EBERSPAECHER WAREHOUSE INFILL PROJECT JSP 17-69

Approval at the request of Eberspaecher North America for Preliminary Site Plan and Storm water Management plan approval. The subject property is located in section 12, South of Thirteen Mile Road and west of Haggerty Road in Office Service and Technology district. The subject property currently has an approximately 63, 957 square feet building with a courtyard. The applicant is proposing to add 7,702 square feet to fill the courtyard gap. A bay door is being added to the south of the proposed building infill.

Planning Review

Review Type: Preliminary/Final Site Plan

SHEET
 Landscape Plan

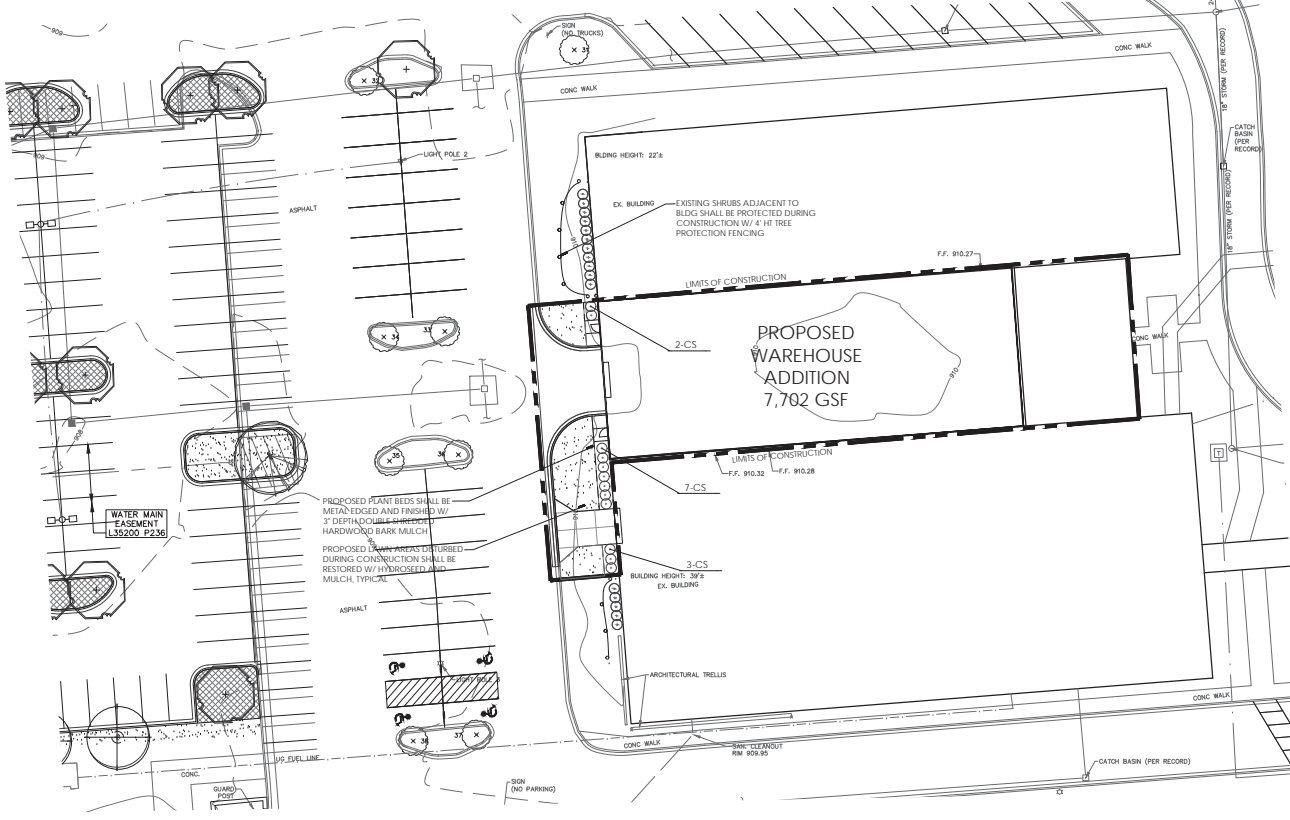
1. Please revise Note #7 regarding replacement of failed plant material to 3 months instead of 1 year.
2. Please copy the landscaping costs provided separately to Sheet L1.

1. Final Stamping Sets shall reflect a revision to Note #7 regarding replacement of failed plant material to 3 months in lieu of 1 year.
2. The landscape estimate will be added to sheet L1.

PROJECT
Eberspächer North America, Inc.
WAREHOUSE INFILL PROJECT
28101 HAGGERTY ROAD, NOVI, MICHIGAN
SHEET TITLE
PROPOSED ELEVATIONS

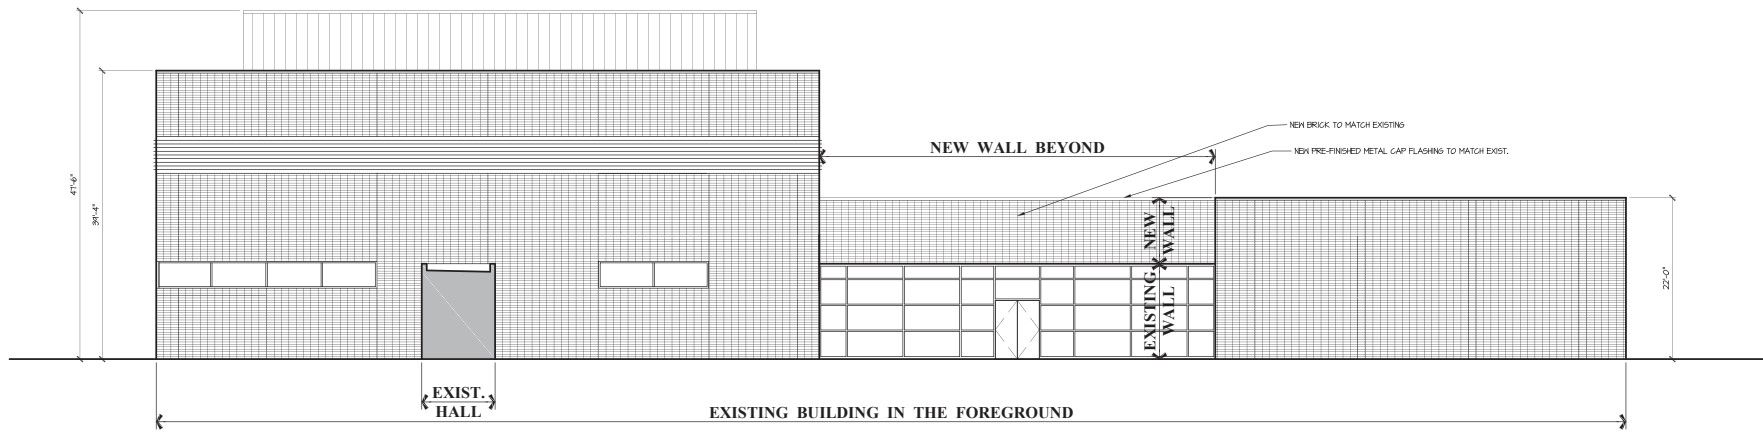
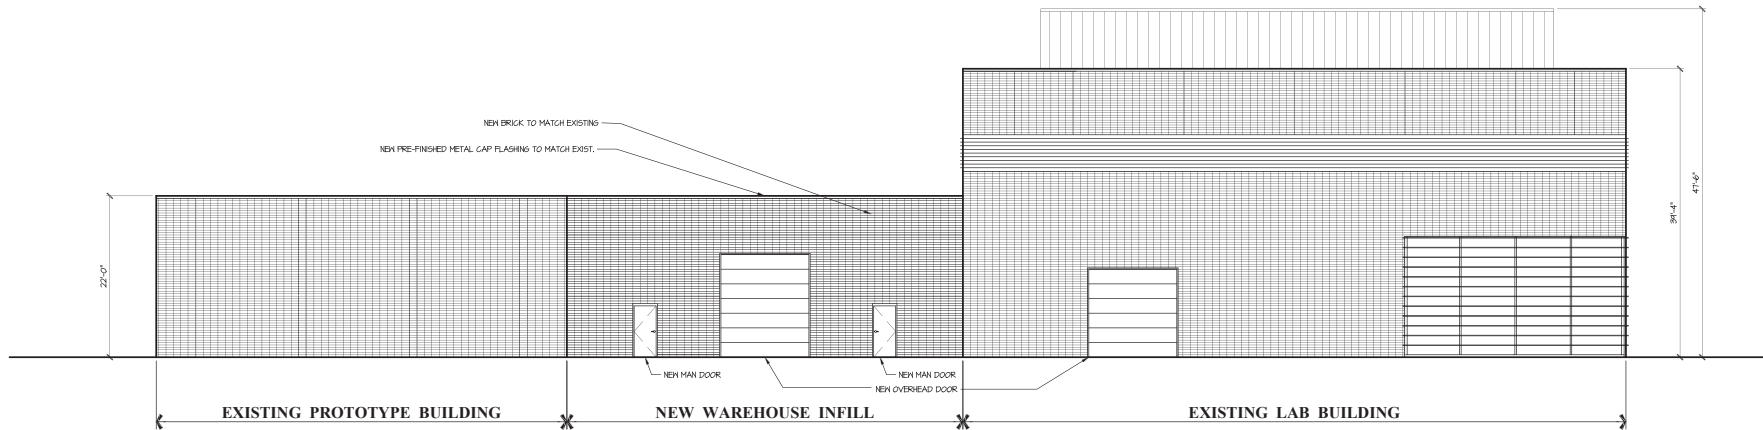
3. Facade Review: The addition appears to be virtually a 100% continuation of existing brick material. This appears to be in full compliance with the Ordinance.
